10 February 2018

Reference: A/18/8/PL for Application for Variation of Condition 2 imposed under A/173/16/PL to read "the development to be carried out in accordance with the following approved plans ADC962/04 REVA, ADC962/13 & ADC962/14 relating to revised position of rooflights on east, north & south elevations. This application affects the Character & Appearance of the Angmering Conservation Area at Land Rear of 1 To 6 The Cottrells Angmering

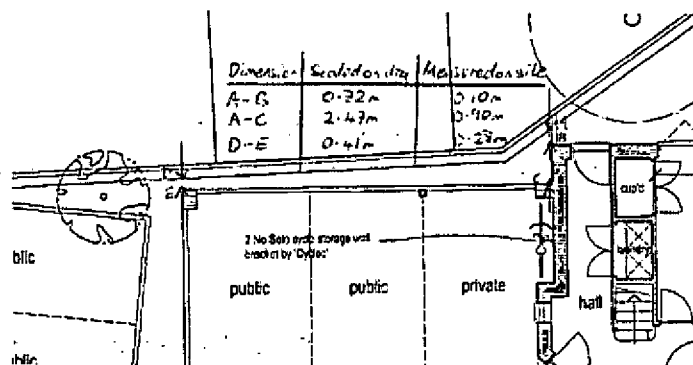
The image below is a scan of an A3 print of the drawing ADC962/04 REVA from which I have scaled key distances between the low block boundary wall and edges of the new building. Against these I have listed the actual distances measured by a Rackhams Chartered Surveyors who carried out a site survey on 2-3 January 2018 with the permission of A M Homes Sussex Ltd.

You can see that the building has been built incredibly close to the boundary. It is now impossible for us to maintain our timber framed garage from our land. It also adds to the visual overpowering impact of the new building when viewed from our garden.

I appreciate that ADC must provide some leeway for siting but this should be centimetres not metres for a building this size. Any distance greater than 25cm is surely an example of incompetence or a deliberate action.

We instructed the surveyor to only measure the elements close to our boundary. I request ADC obtain an accurate set of detailed building plans, establish if they match the approved and submitted plans and carry out a visit to verify my measurements and also establish if the building has been built bigger overall.

I request that these parts of the building on the northern elevation that have been built incorrectly are demolished and rebuilt according to the plans.

Drawing ADC962/14 (A/8/18/PL)

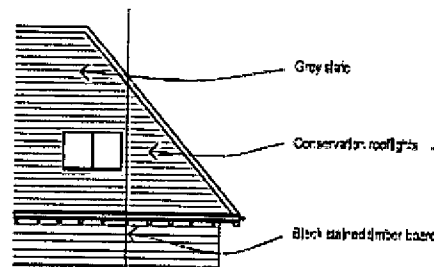
The image below is taken from drawing 02 REVC for application A/173/16/PL and defines the rooflights as "Escape roof-lights". I interpret this as a window that is not designed to be openable on a day to day basis. I assume they were described as this to reduce the impact on privacy for the neighbours.

Alongside is an image from the submitted ADC962/14. The rooflights that have been installed are described as "Conservation rooflights". When viewed from the ground, they appear to be standard Velux windows and we have seen that they can be easily opened (by the builders during construction). This has improved the quality of the building materially and reduced the privacy for the neighbours.

I request that the installed openable Conservation rooflights are removed and replaced with Escape roof-lights as in the approved plans.

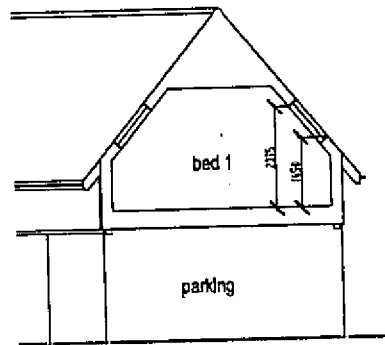
I understand that ADC's guideline distance from the internal floor to the the bottom edge of rooflights is 1.7m. The granted plans define 1.5m.

I do not understand why this building was given special permission to break this guideline.

The image below is from drawing ADC962/14. The distance of the installed window shown is 1.45m and the application is seeking permission for this, a full 0.25m lower than the guideline.

I request that ADC measure the other windows to ensure they have been built to 1.50m and reject this application for those built to 1.45m.

The view from Bedroom 1 overlooks our property and has approval for a rooflight with the bottom edge 1.5m from the floor. As I write this, sitting in our kitchen, I have a direct line of site to this window. **I request that the glass in this rooflight be frosted to preserve the privacy of us and the occupants.**

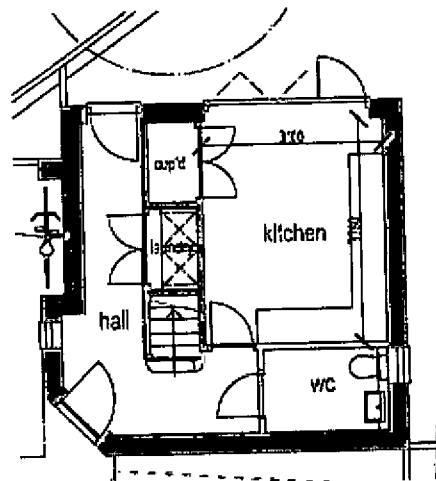
The rejected plans A/162/16/PL identified the kitchen upstairs and a Bedroom 3 downstairs. The submitted plan matches the original two bedroom layout with the kitchen upstairs but the building has been built with a new internal corridor and access door next to the french windows (see image below). This is very appropriate if a Bedroom 3 is downstairs.

I believe that there is a high likelihood that once the building has been signed off by ADC, the developers will reconfigure the interior to match the rejected plans. The significance of the additional Bedroom 3 is that this brings a high possibility that the occupants will have another car and this will need to be parked in this already very congested neighbourhood. Naturally a three bedroom property will have a higher sell price than a two bedroom one.

I request that a clause be placed on the new building requiring planning permission to be required for any modifications to the internal layout. If you do not do this, the planning process will have been
